To: Montgomery Township Zoning Board of Adjustment

Re: **Stellar Land Assets, LLC**
Preliminary and Final Major Site Plan with Variances
316 Wall Street
Block 35001, Lot 15 & 16
HC - Highway Commercial

Date: February 26, 2024

STELLAR LAND ASSETS, LLC | USE AND BULK VARIANCES

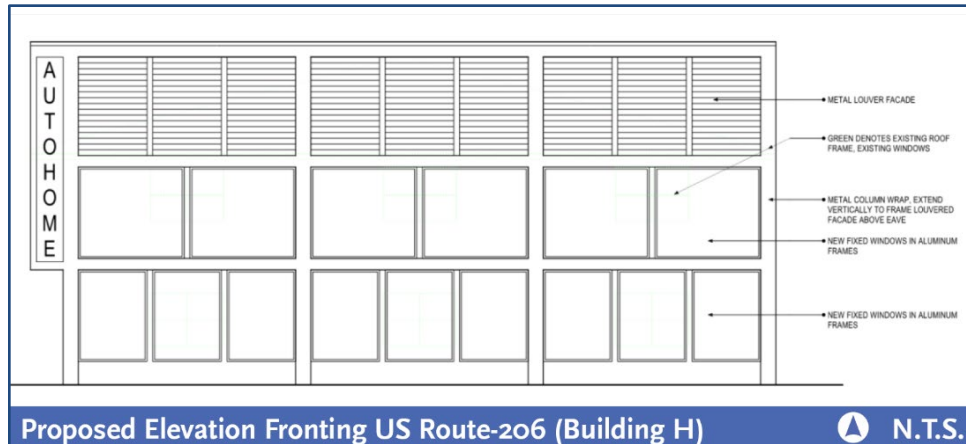
- 8.1. **Architectural and Building Standards in the HC District:** Section §16-4.12e contains requirements for all buildings and sites within the HC district.
- 8.2. **Proposed Design:** The plan proposes facades of a contemporary industrial style composed of metal louvers, metal column wraps, aluminum window frames, and glass windows varying in size and rhythm as shown in the exhibits from the architectural plans below. The proposed designs of Building G and H are nearly identical.

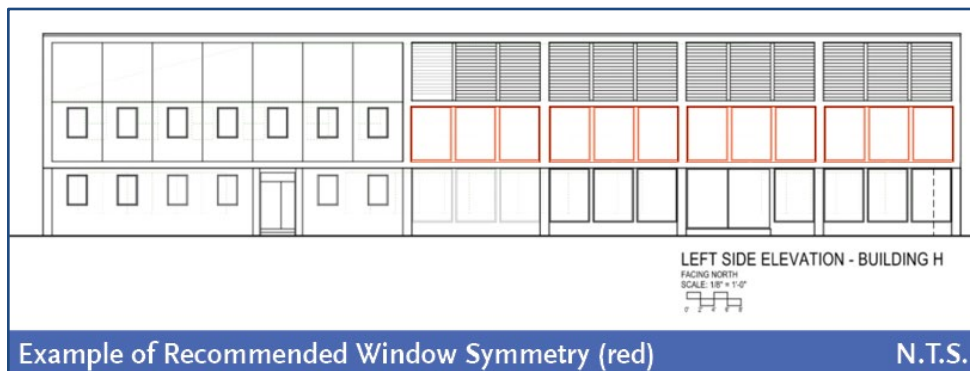
8.13. Roofline Compatibility: Pursuant to §16-4.12e.6(a), the design of all buildings within a development shall include rooflines that are architecturally compatible or in context with existing buildings in the vicinity of the subject building. Within this context, rooflines that mix flat and pitched components are encouraged.

The rooflines of nearby buildings are flat, pitched, or a combination thereof. Other buildings within the existing business park along Wall Street have pitched roofs, while existing car dealerships along US Route-206 have flat roofs. The plan proposes to replace the existing pitched roofs with flat roofs. The plan complies.
